# NOTICE OF ALLOWANCE AND FEE(S) DUE

APPLICATION NO.	FILING DATE	FIRST NAMED INVENTOR	ATTORNEY DOCKET NO.	CONFIRMATION NO.
10/791,581	03/02/2004	George Liang	N1089	3469

TITLE OF INVENTION: LEADING EDGE DIFFUSION COOLING OF A TURBINE AIRFOIL FOR A GAS TURBINE ENGINE

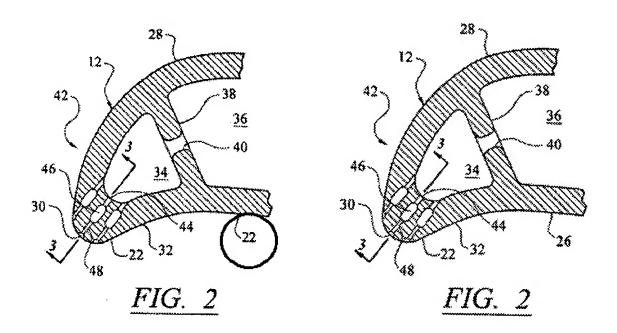
The numeral "22" in Fig. 2 should be -- 26 --. See reproduced figures below wherein the drawing on the left identifies the error and the drawing on the right shows the correction. In order to avoid abandonment of the application, applicant must make this drawing change.
